Addendum #1

Project No.: ERBR-SA-75(A022)
Addendum No: Addendum #1
Date: November 19, 2020
Owner: City of Vicksburg

This addendum is to revise **Sheet VII – Intermediate Bents 2 & 3 and Sheet VIII – Intermediate Bent Details** by correcting dimensions and splice notes on the columns.

CITY OF VICKSBURG KEMP BOTTOM ROAD BRIDGE		
INTERMEDIATE BENT DETAILS		
PROJECT NO. ERBR-SA-75(A022)		
 Stantec Civil/Structural Engineers Vicksburg, Mississippi		
DESIGNED: T. ENNIS	DETAILED: J. HAGENBUSH	DATE: 10/9/2020
CHECKED: J. KELVINGTON	CHECKED: B. JOHNSON	SHEET NO.: VIII

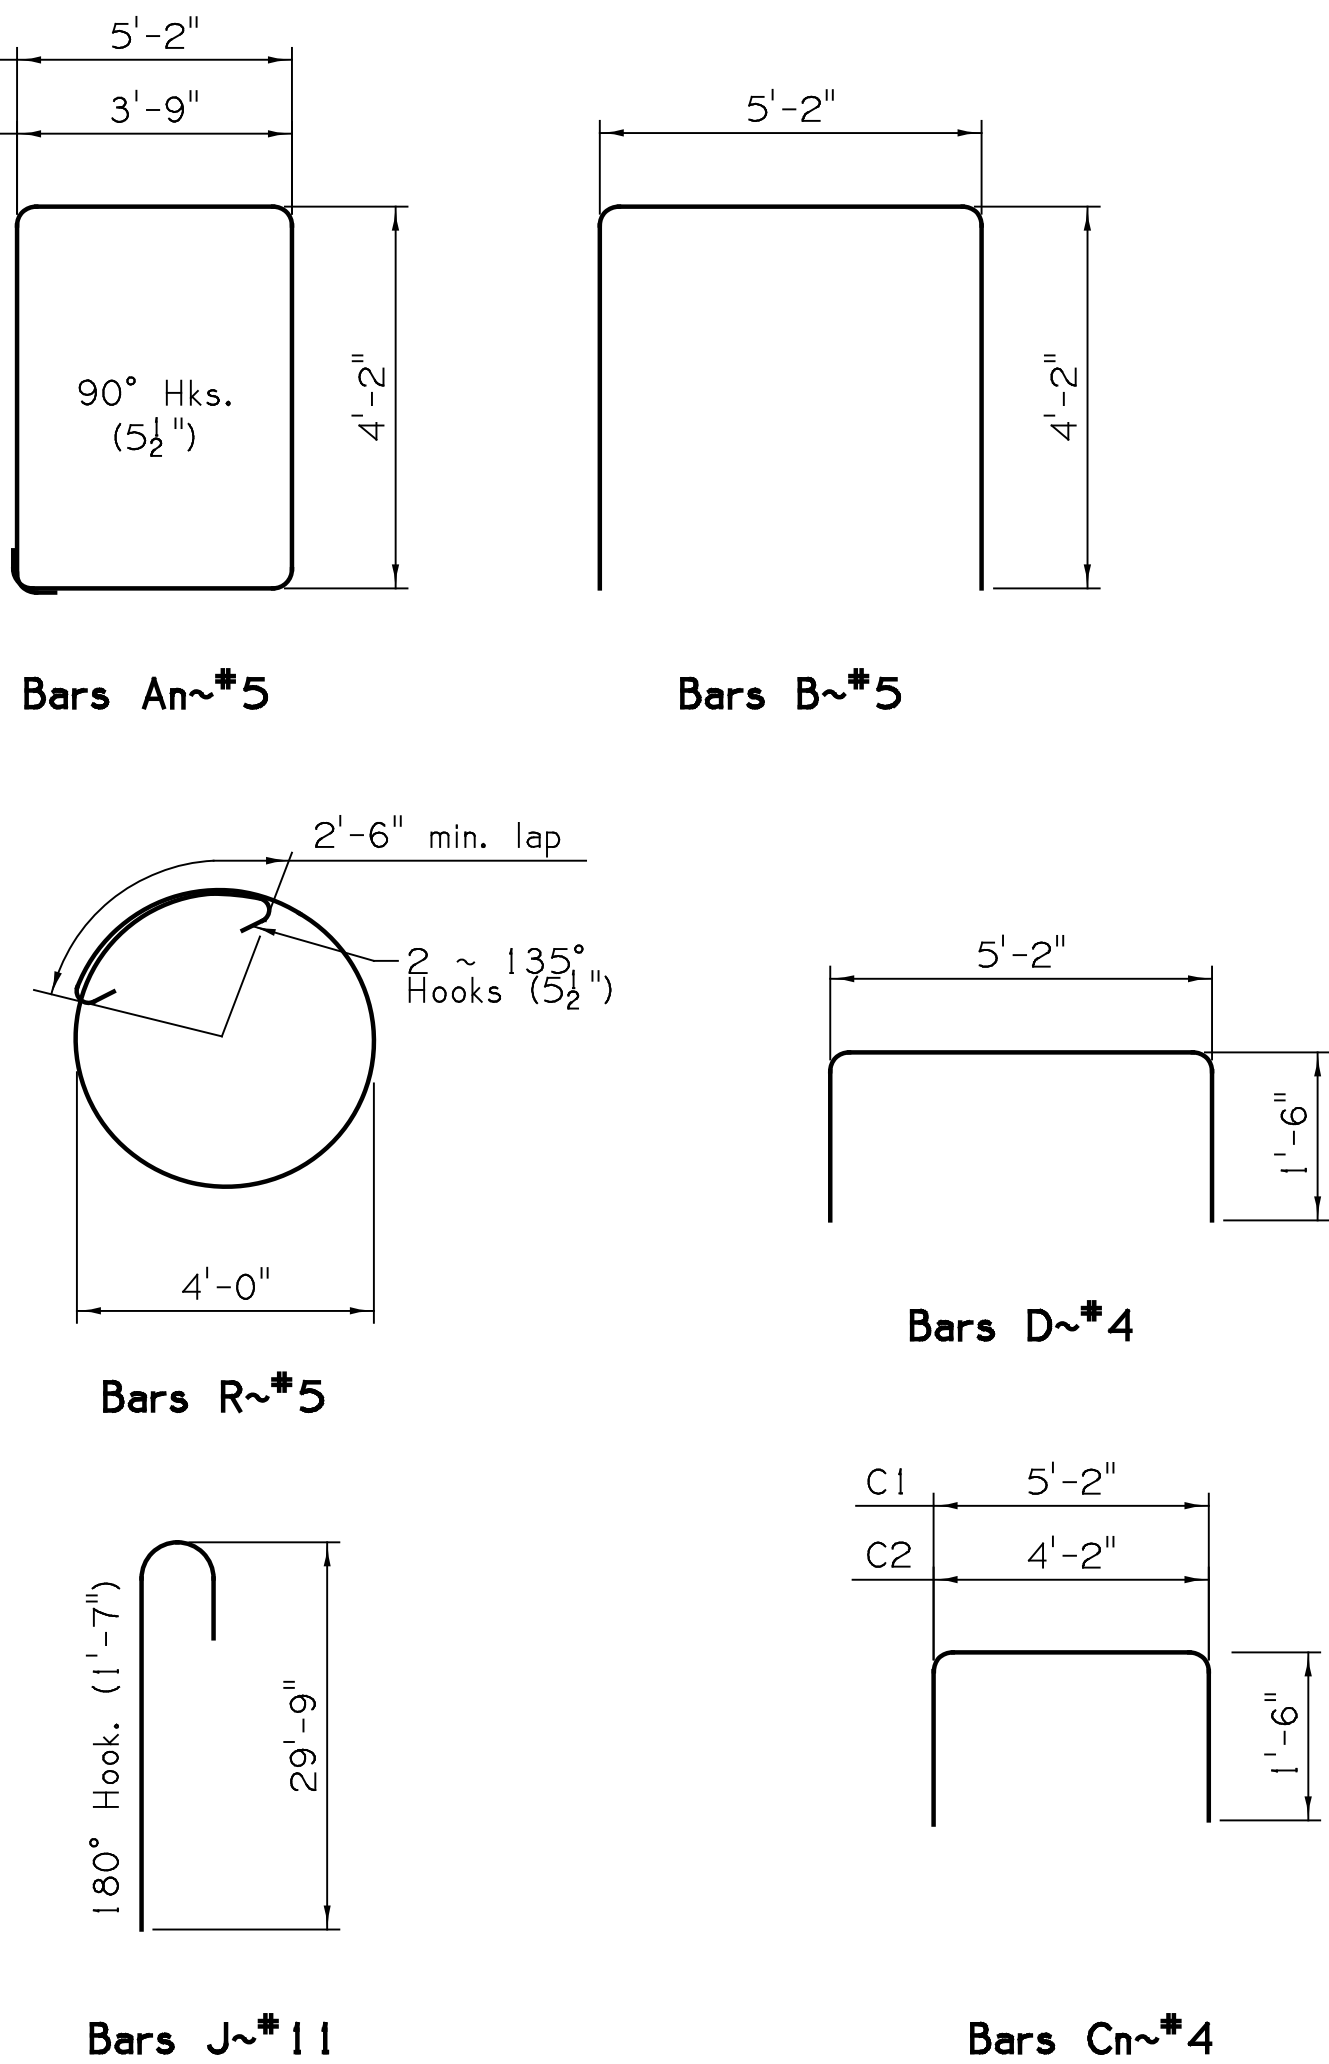
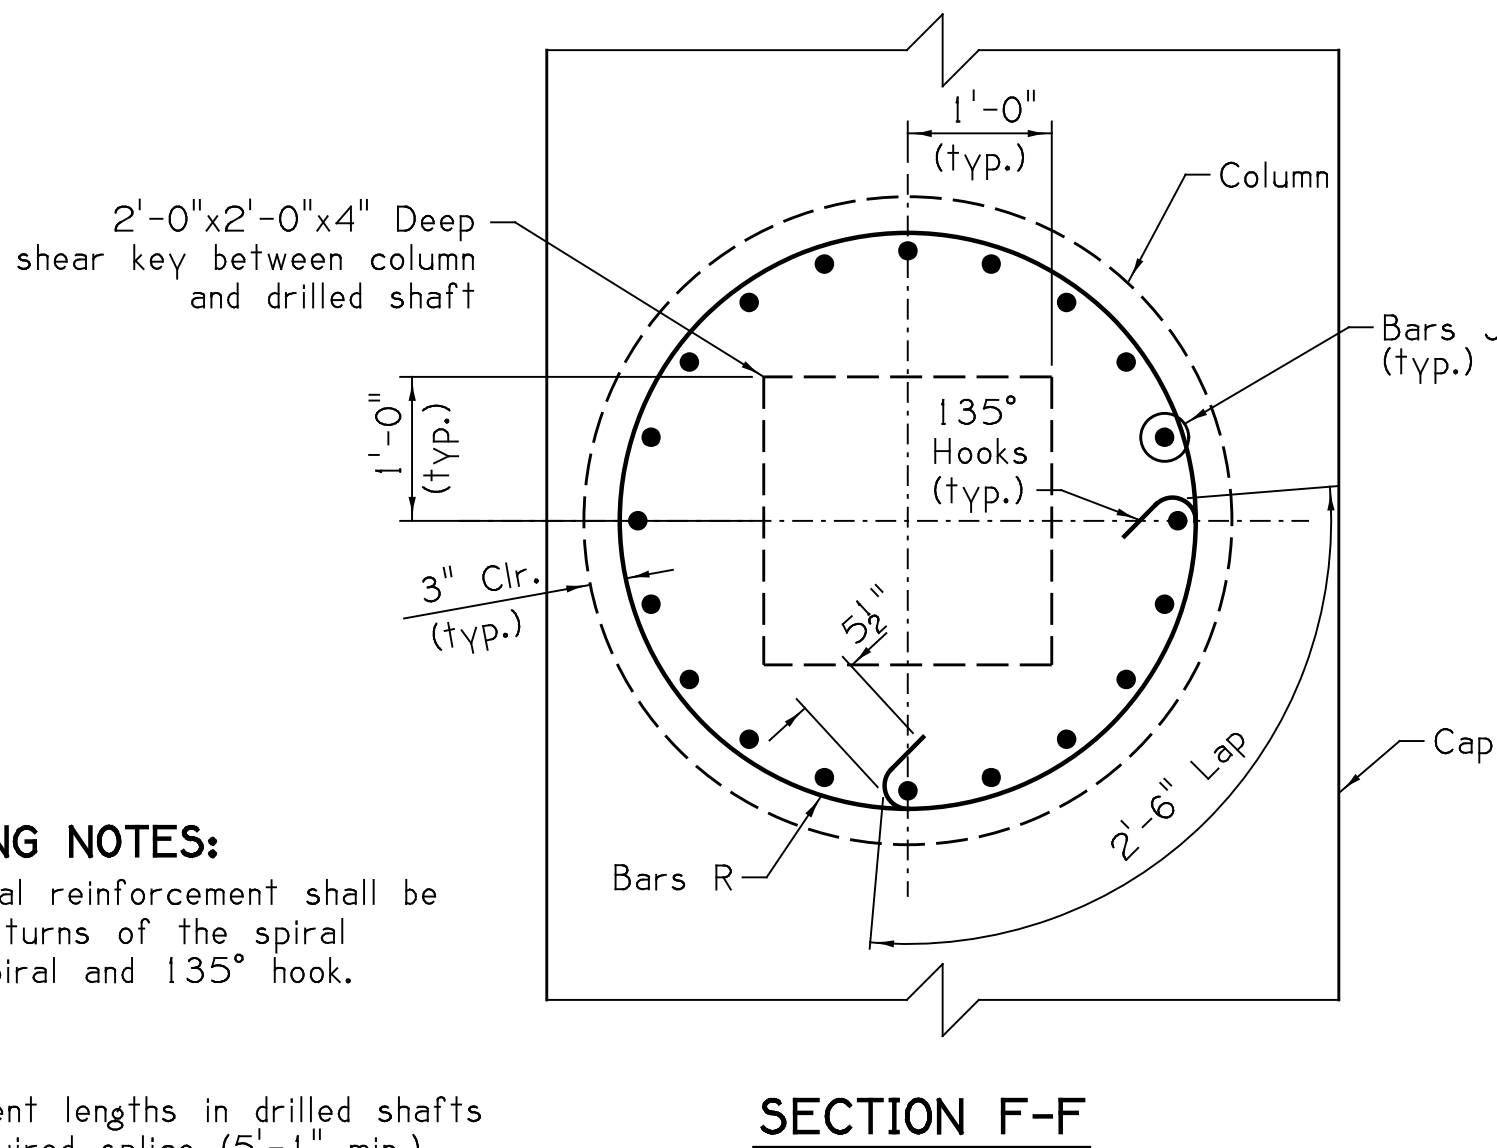
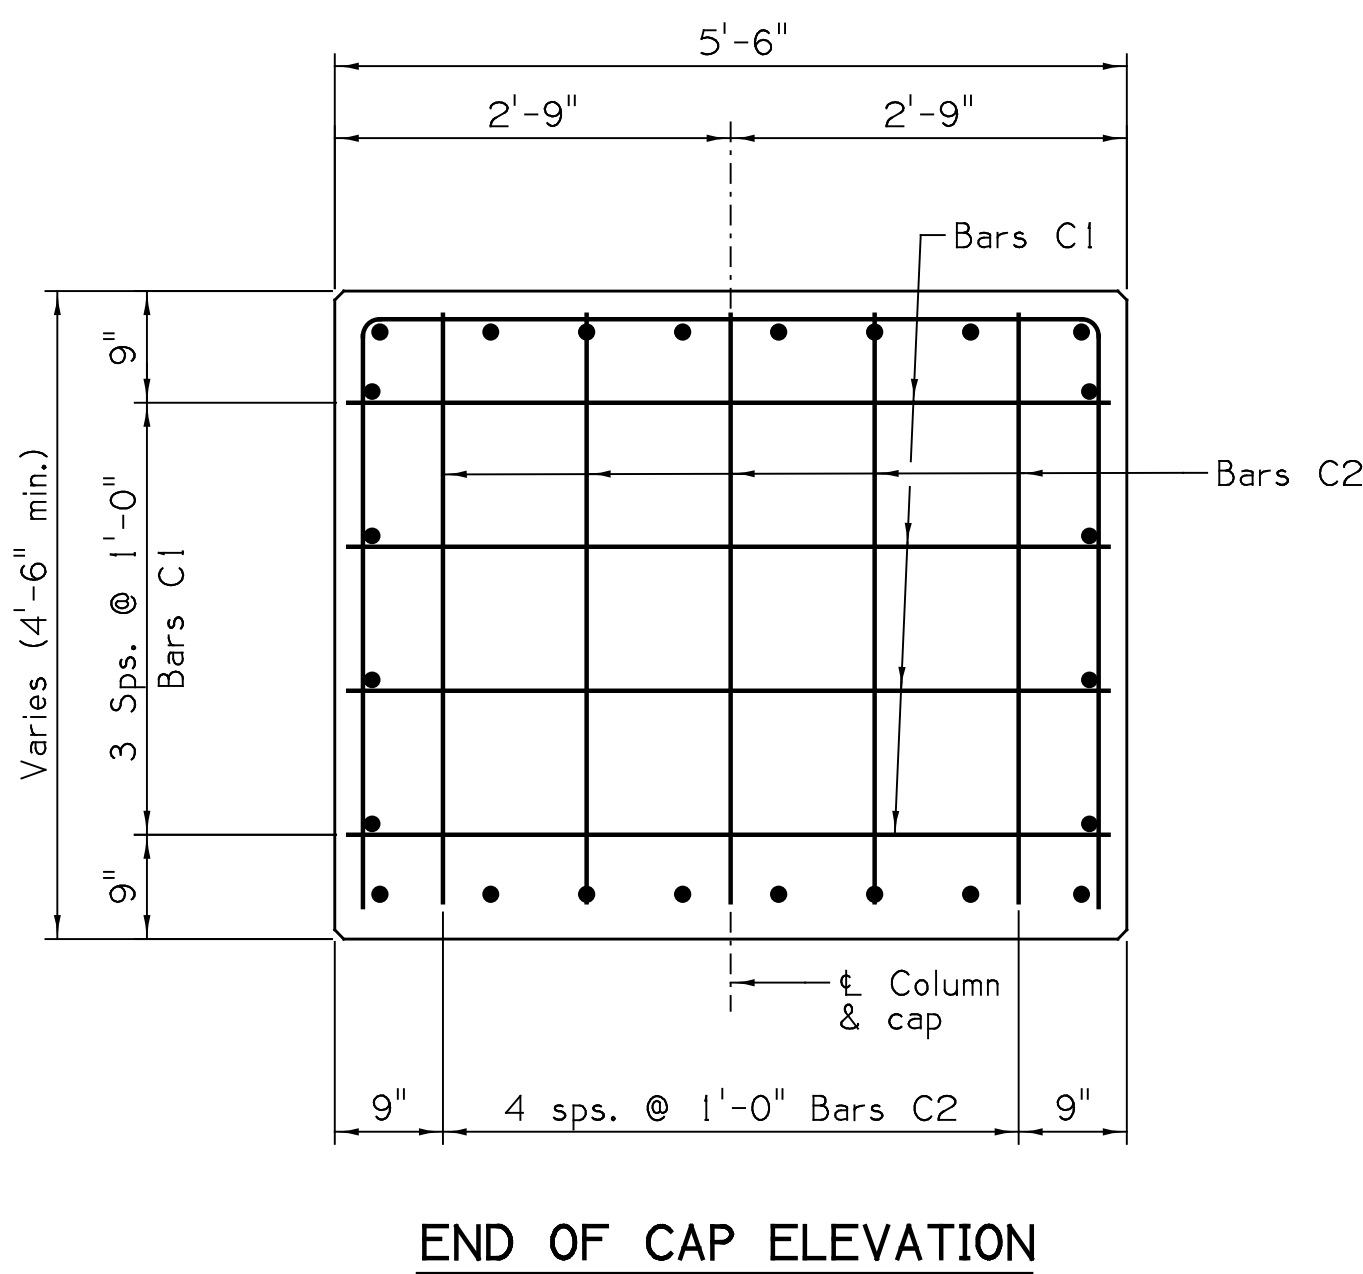
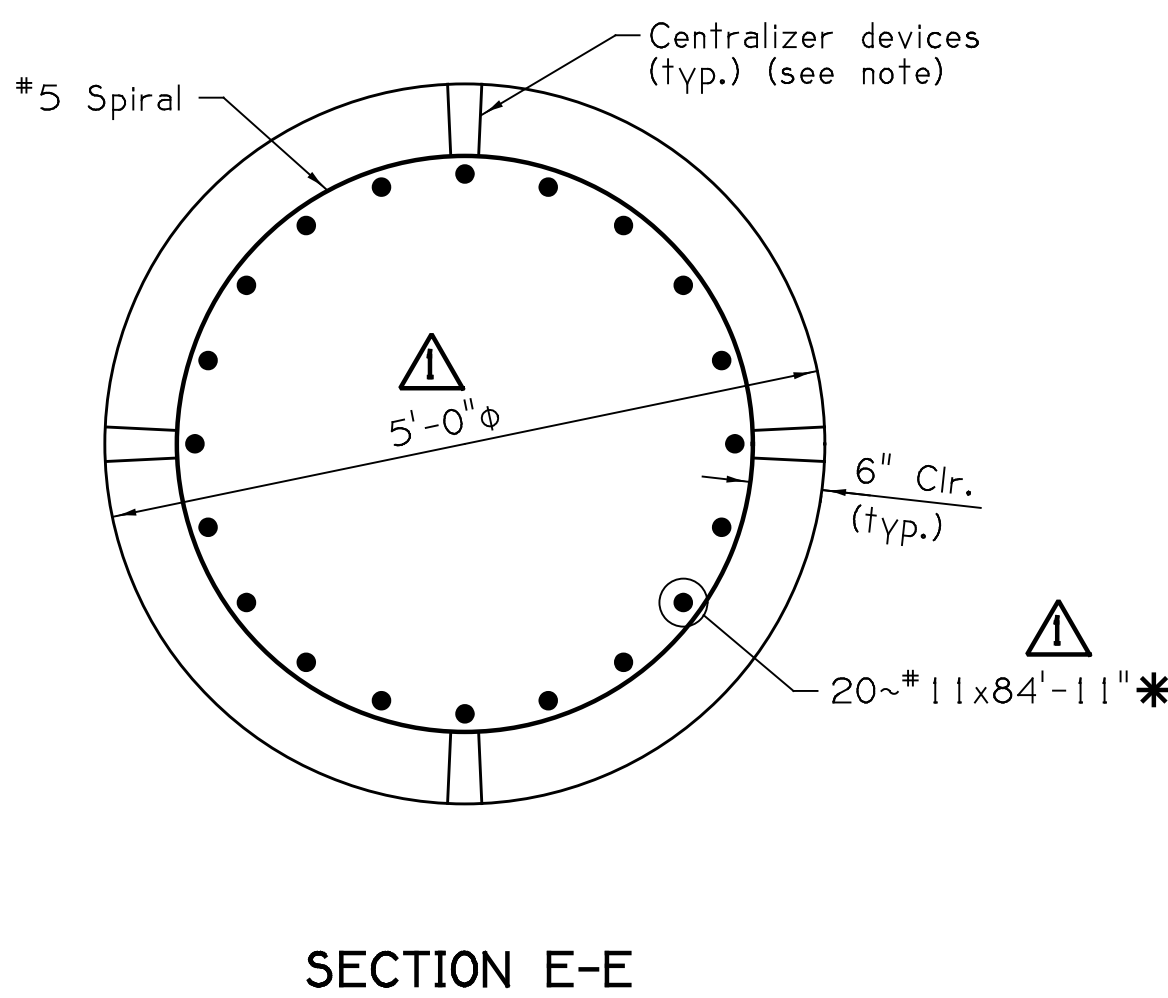
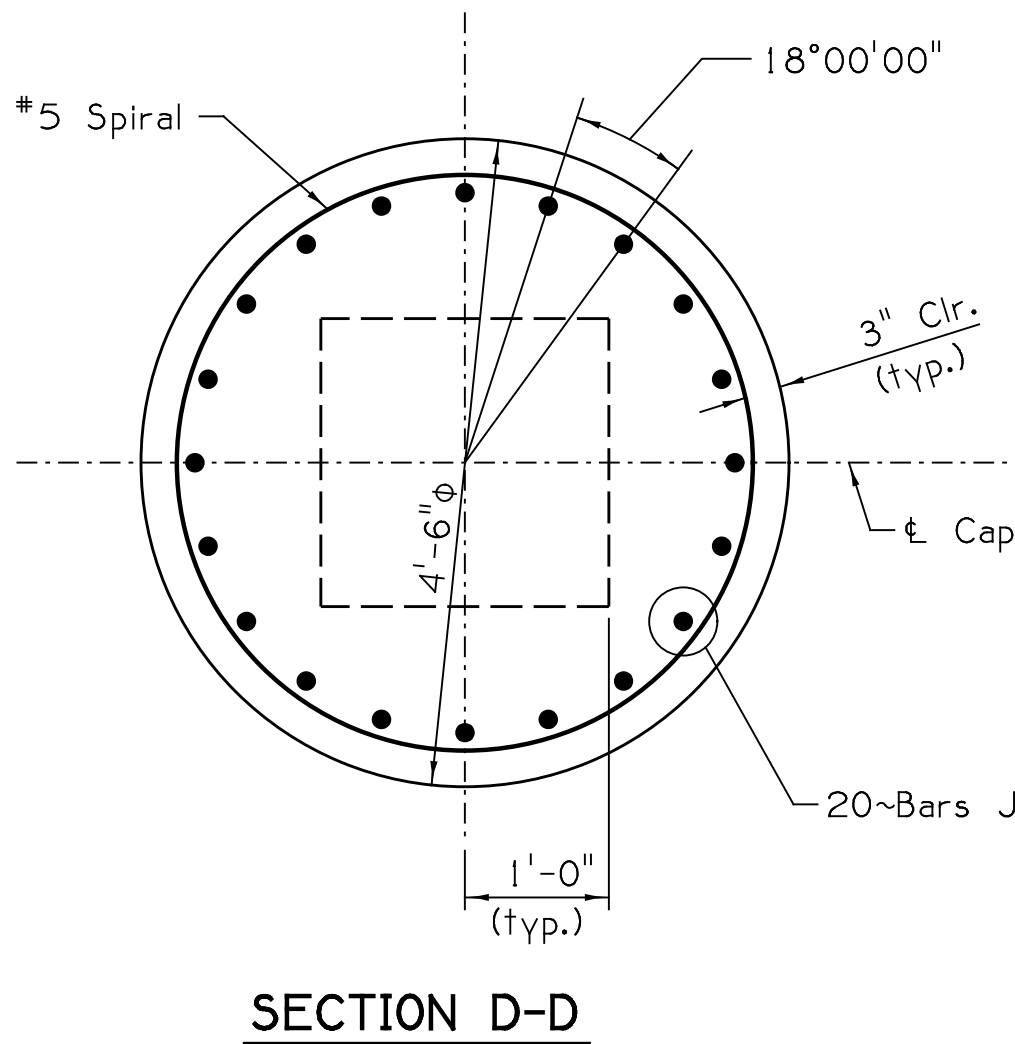
11/19/20	CORRECTED DIMENSIONS, REVISED SPLICE NOTE	JBJ
DATE	DESCRIPTION	BY
	REVISIONS

SPLICE NOTES:
* Longitudinal reinforcement lengths in drilled shafts do not include the required splice (5'-1" min.).

Longitudinal reinforcement in drilled shafts may, at the Contractor's option, be spliced using mechanical splices located 2'-0" staggered between bars.
